DEVELOPMENT REVIEW BOARD
Code Enforcement Comments

(AKA: PR-2021-006287)
PR-2021-006297
SD-2022-00039 – PRELIMINARY/FINAL PLAT

PROJECT NAME:
COMMUNITY SCIENCES CORPORATION agent for **RACHEL MATTHEW DEVELOPMENT CORPORATION & THE SANTA BARBARA HOMEOWNERS ASSOCIATION/ELISA CARDENAS** requests the aforementioned action(s) for all or a portion of: **LOT 2 BLOCK 16, SANTA BARBARA SUBDIVISION zoned R-T, located at 7300 SANTA BARBARA RD near RANCHO DE PALOMAS RD NE** containing approximately X acre(s). (D16)
[Deferred from 3/9/22, 4/6/22, 4/20/22, 4/27/22,5/4/22, 5/11/22]

REQUEST: SUBDIVIDE ONE LOT INTO FOUR LOTS

Screen shot excerpt of 3/9/22 submittal showing allowed "Net Lot Sizes" for Area of Consistency:

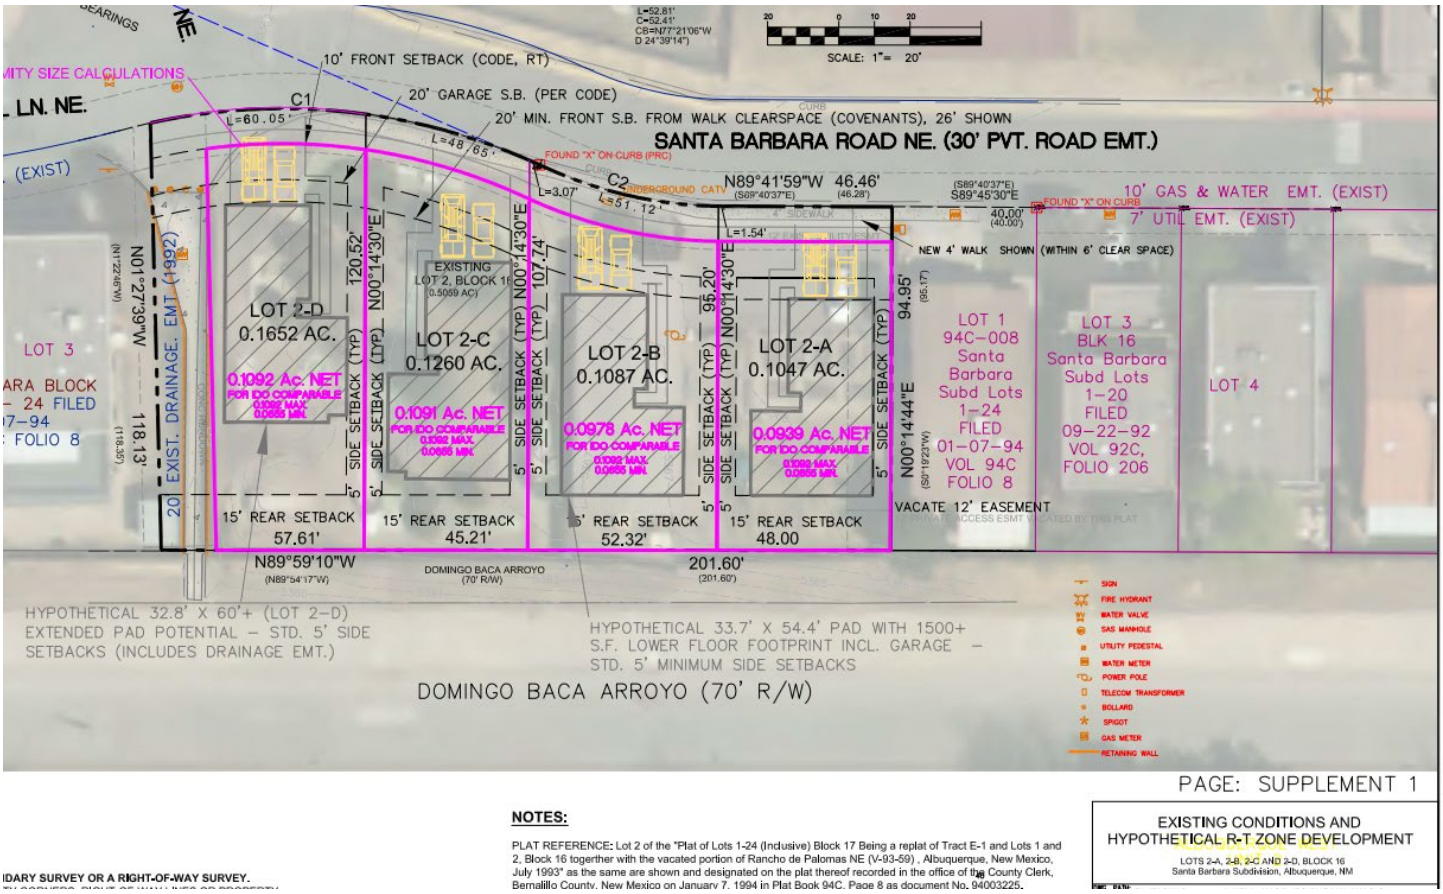
1. Property is zoned R-T and is located in an Area of Consistency. All standards and requirements of the IDO, DPM, and other relevant City regulations must be met.
2. As per prior communications with Planning Staff and calculations of Area of Consistency, these lot sizes must fall within .0655 acre minimum (75%) and .1092 acre maximum (125%) for consistency. The modified net size of proposed lots falls within what is allowed by the Area of Consistency calculations.
3. No additional comments or objections.
